TRACKED VEHICLES
E 109 Misc Instr No 1

CARRIER, ARMoured, TRACKED, 15-TON (FV 430 SERIES)

TECHNICAL HANDBOOK - MISCELLANEOUS INSTRUCTION

Fig 3 - FV 433 fuel tanks - assembly
END

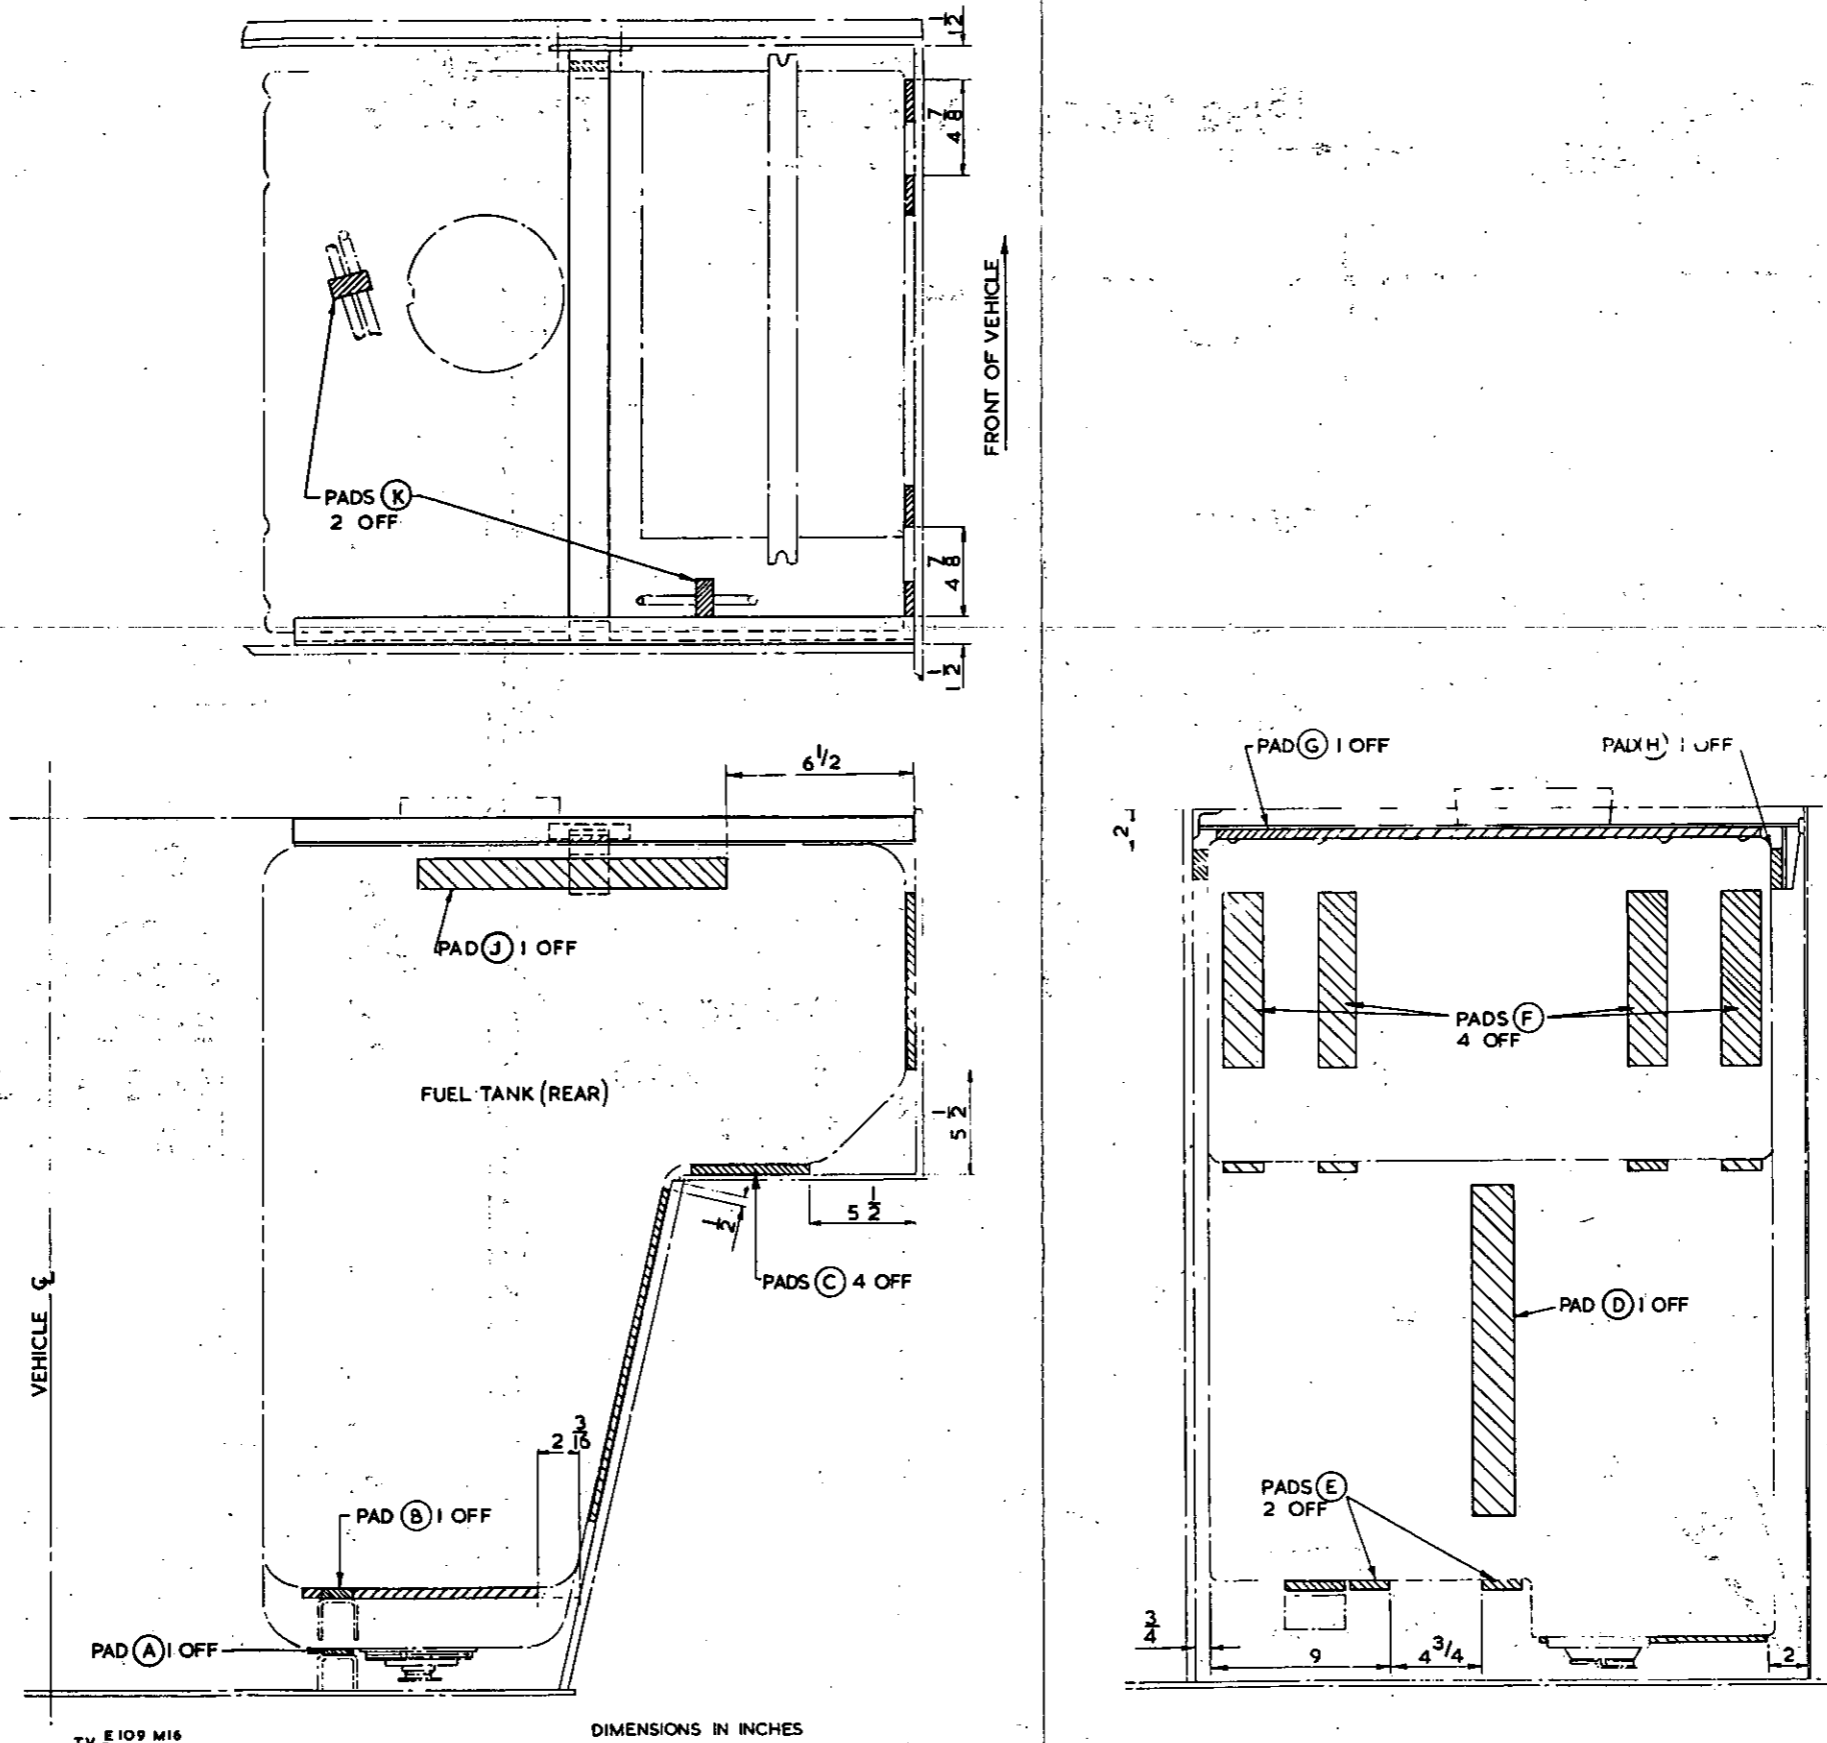
(3) See Fig 3. Secure the manufactured pads to hull side and bottom plate at dimensions shown using the Araldite and hardener listed in para 4b.

Fig 1 Suction tube and bridge plate

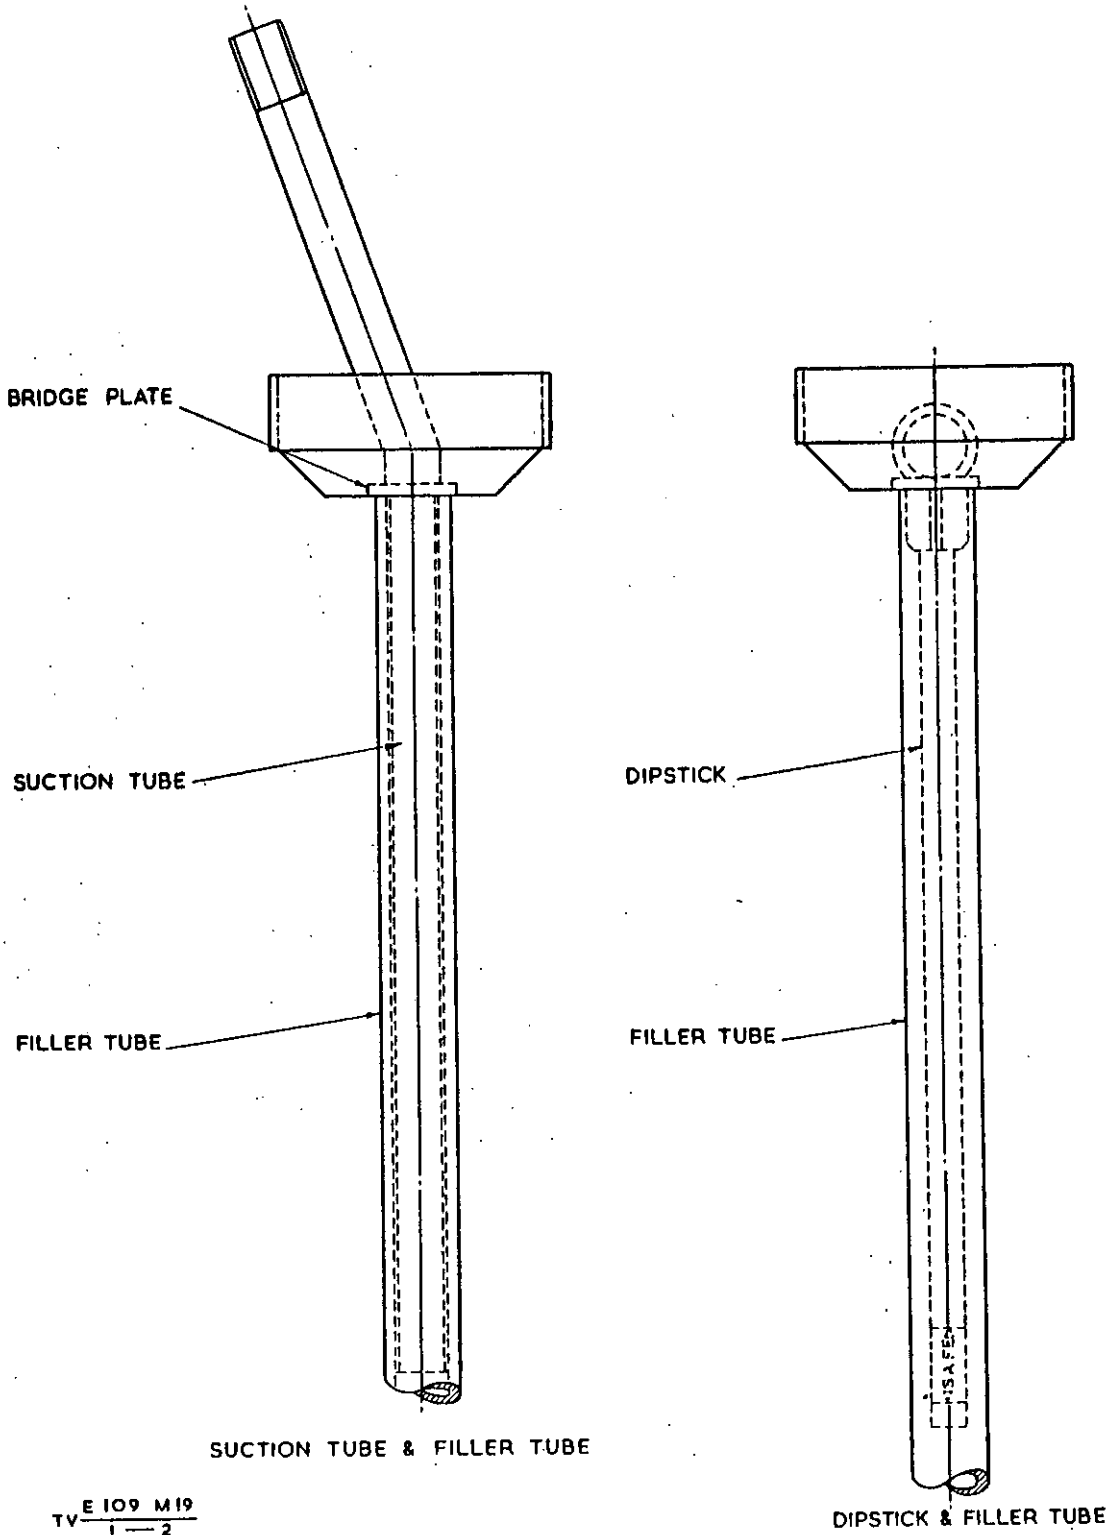
- (1) Manufacture bridge plate, see Fig 1.
- (2) Manufacture suction tube, see Fig 1 and braze bridge plate to tube in the detailed position. Screw suction tube to pump using leather washer and lock-nut, supplied with pump, to lock suction tube in position.

Fig 1 - Drilling detail - Coupling-shaft flexible

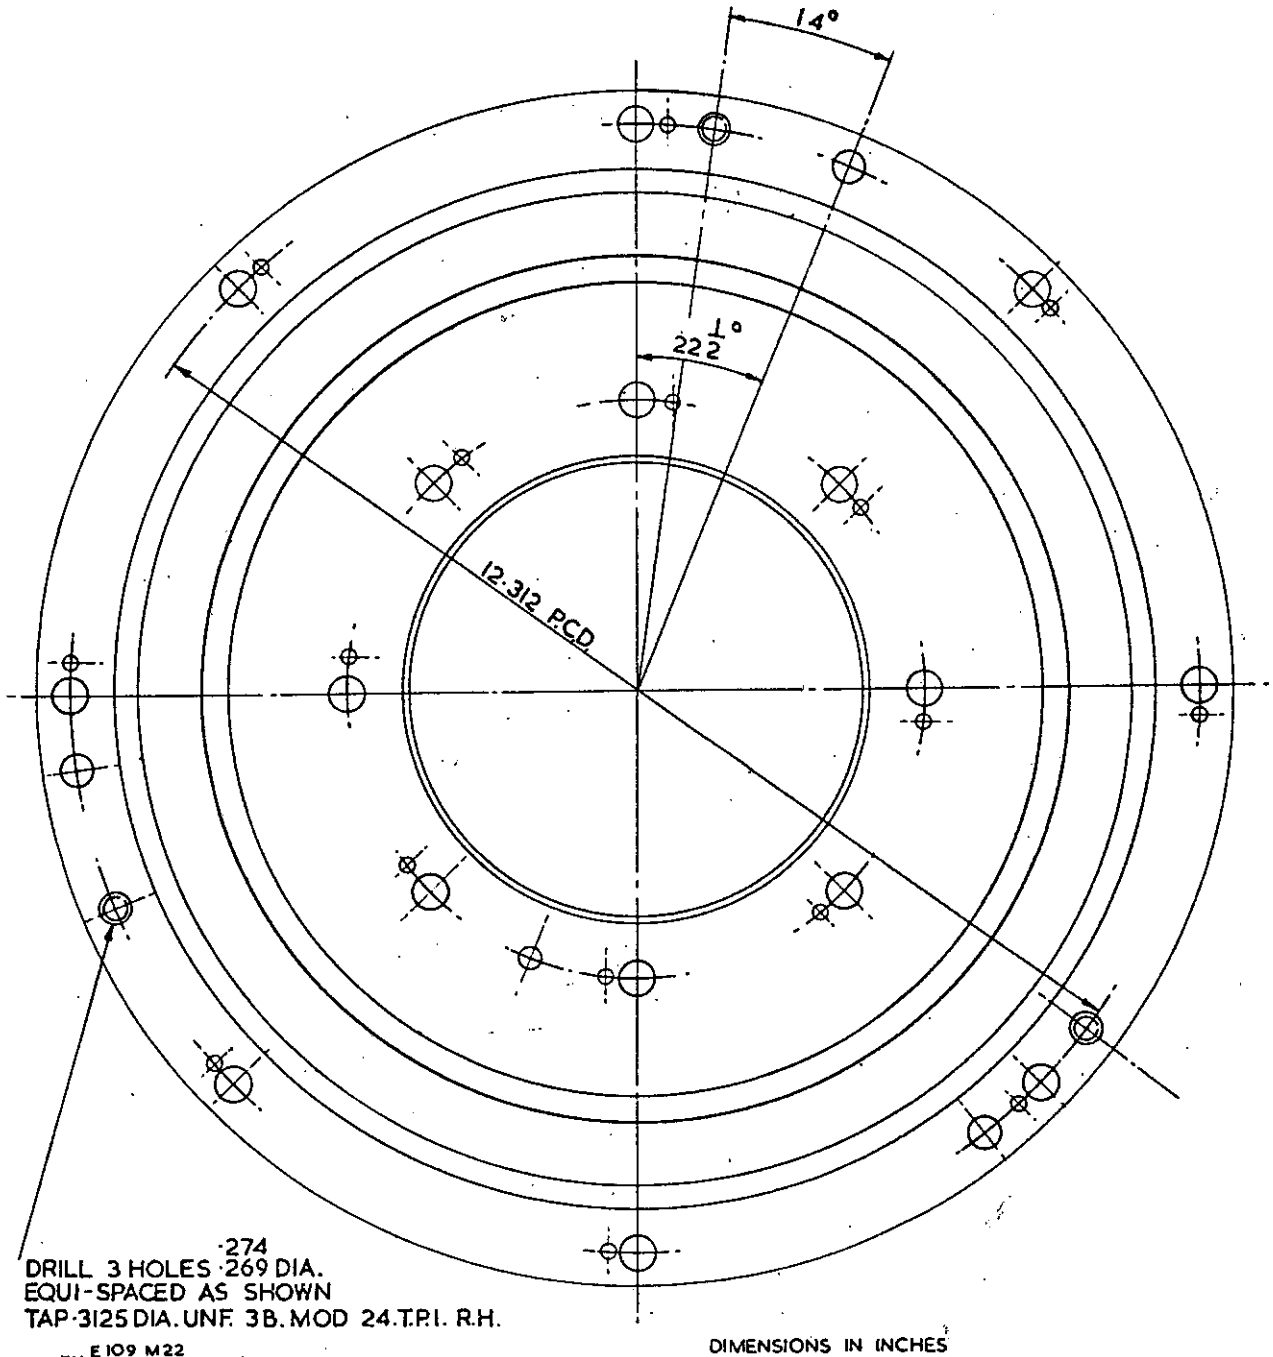
See Fig 1. Drill and tap three 5/16 in. UNF holes as shown.

Fig 1 - Fitting detail for 'Honeywell' switches

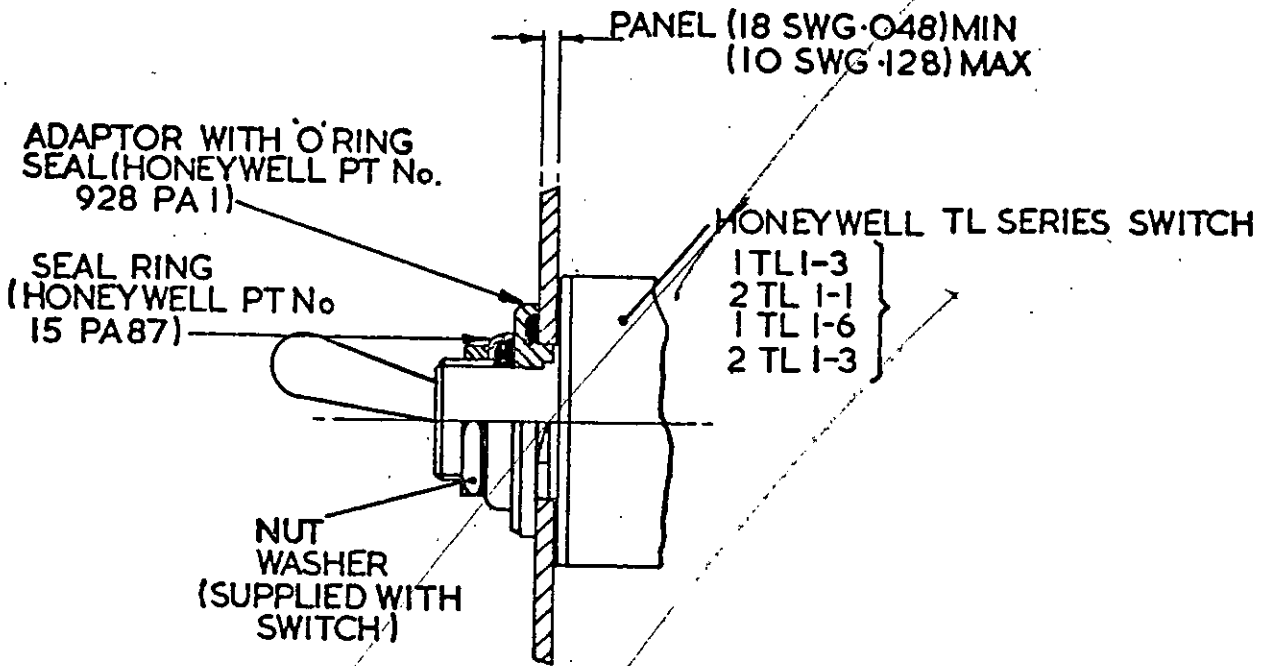
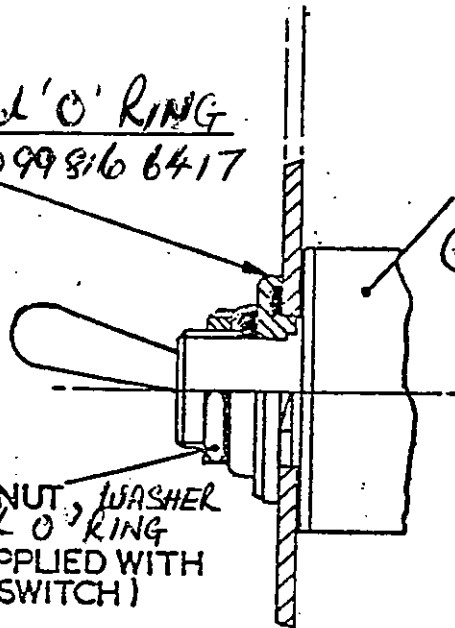
b. The following 'Honeywell' switches will be introduced into service and also created as maintenance spares together with the items shown at para 4a.

*This drawing is
questionable*

On receipt of adaptor, remove existing O-ring
and place in place - demand and get this delivery
6MT4 / 533099 866 6988

Fig 1 -- Driver's seat -- detail

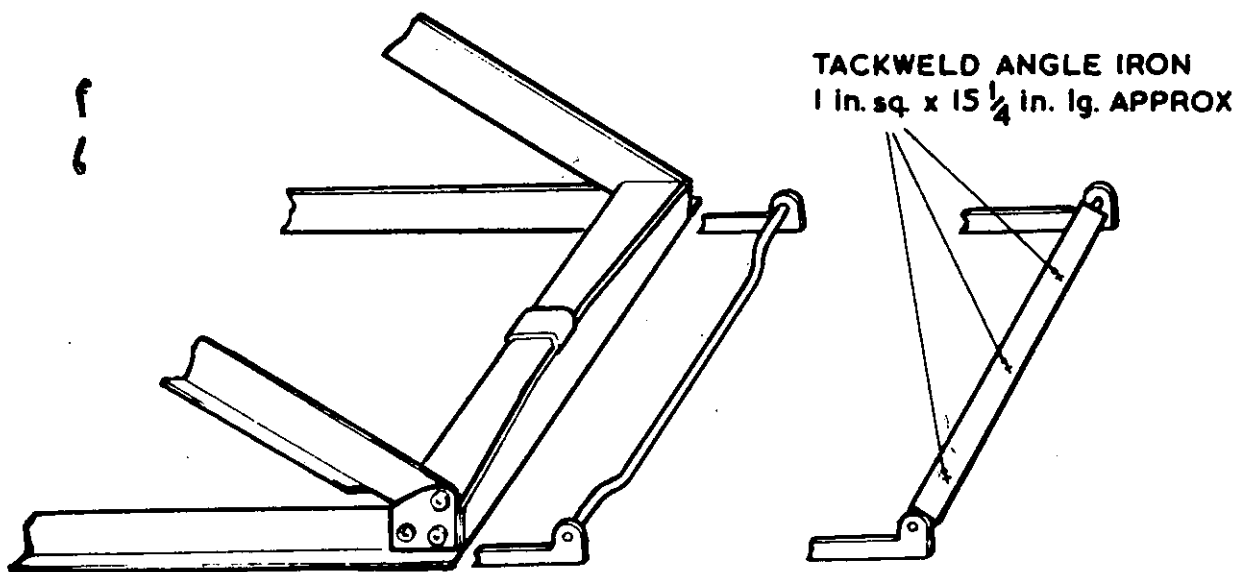
b. See Fig 1. Make up a length of angle iron to the dimensions given, and tack-weld angle to bar as shown.

Fig 1. Manufacturing and fitting detail
(Dimensions in inches)

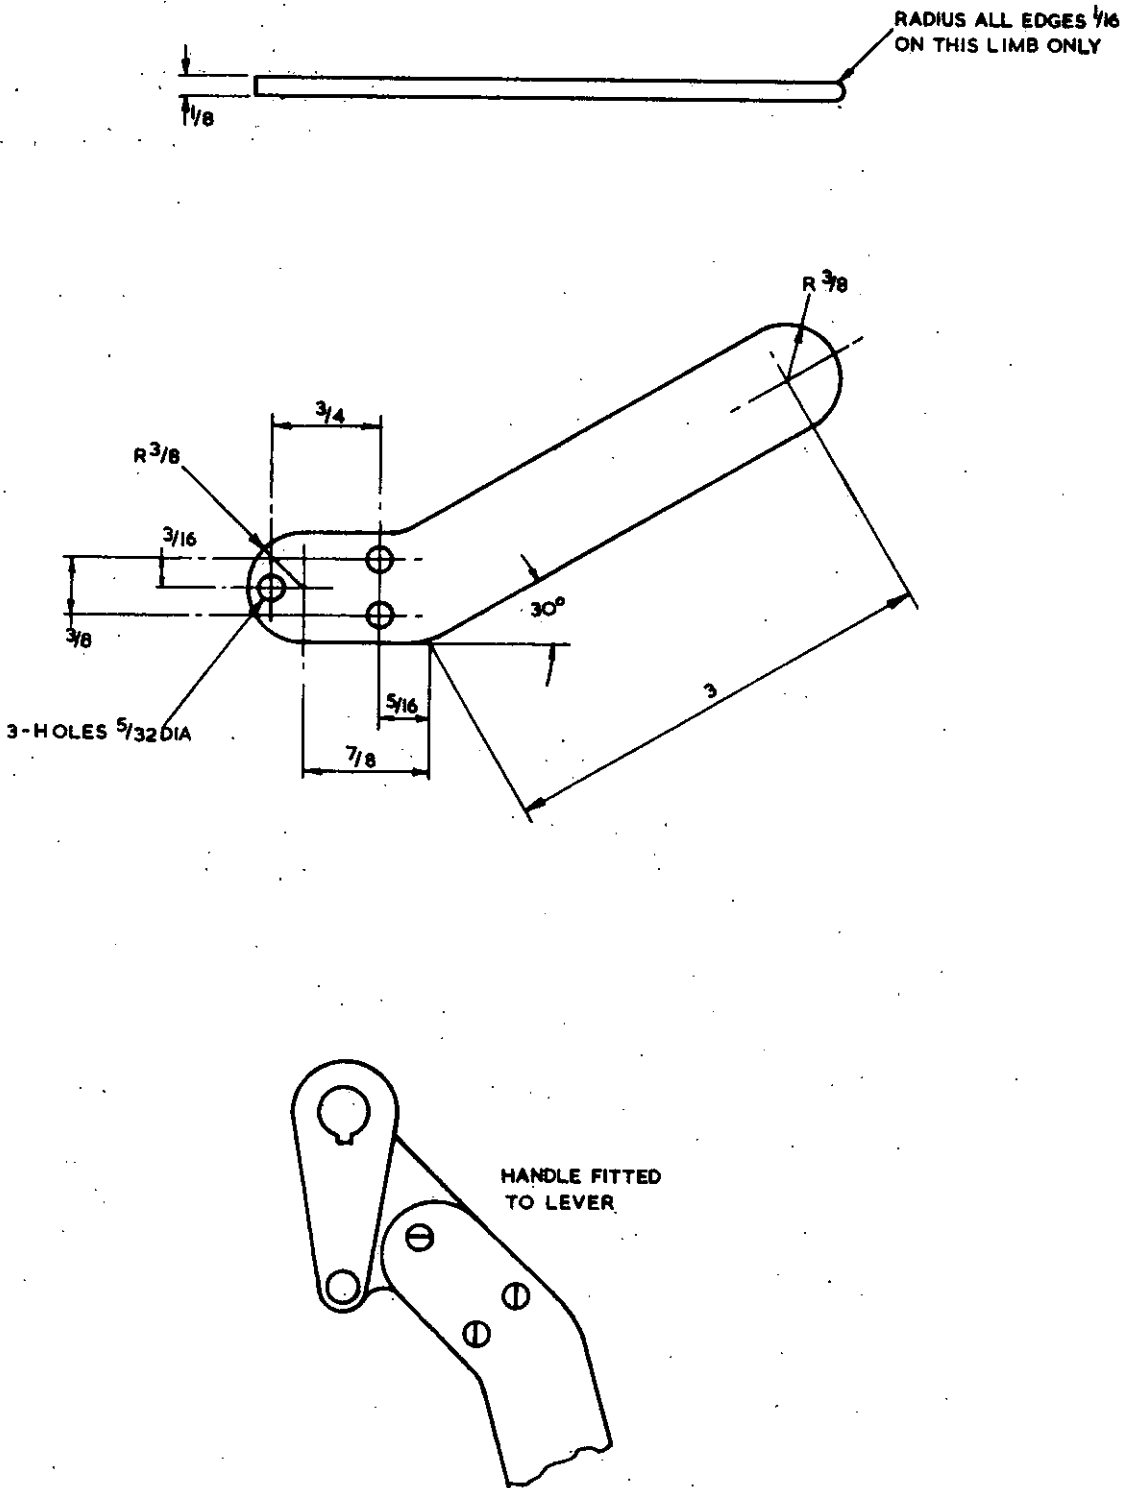
5. a. Manufacture handle as detailed in Fig 1.

b. Fit manufactured handle to periscope mounting assembly in place of straight handle, as detailed in Fig 1, and peen over screw ends.
